Subject: Draft Renewal of NPDES Permit AL0001449
Tyson Farms, Inc.- Blountsville

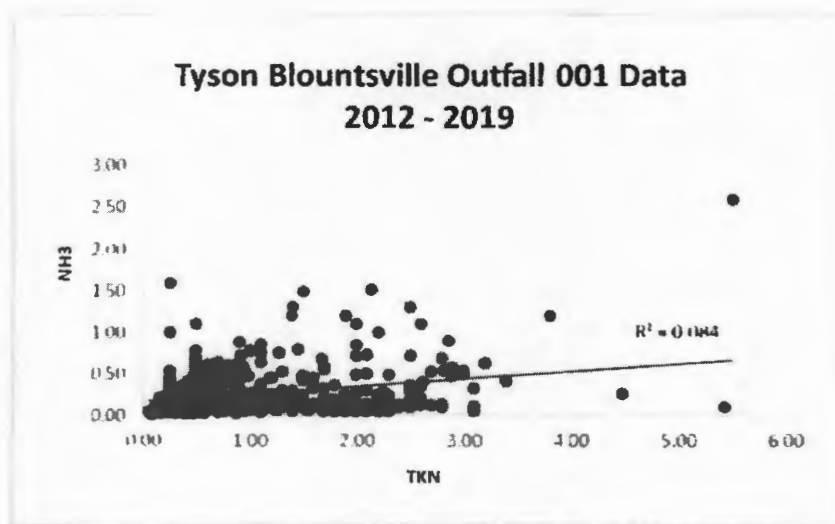
3. In the proposed permit renewal, it appears that the Department used a factor of 2.0 and multiplied that factor by the proposed NH₃ limit to obtain our new TKN limit. While the rationale indicates that this approach is Best Professional Judgement, Tyson would like to understand the basis for the 2.0 multiplier. Tyson conducted an evaluation of the TKN and NH₃ data for the 7½ years that we have operated under the current permit. As presented in the following chart, we do not find a consistent relationship or correlation between NH₃ and TKN.

Based on our 7 year dataset, the ratio between TKN and NH₃ has ranged from 0.2 to 62.0 with no statistical correlation ($R^2 = 0.084$). We believe a TKN limit based on a correlation between TKN and NH₃ is not appropriate. We anticipate the wastewater system upgrades currently under construction will result in lower discharge TKN concentrations; however, we have no basis to predict those future concentrations. We respectfully request the Department maintain our current summer season daily maximum TKN limit at 4.8 mg/L and our monthly average limit of 3.2 mg/L.
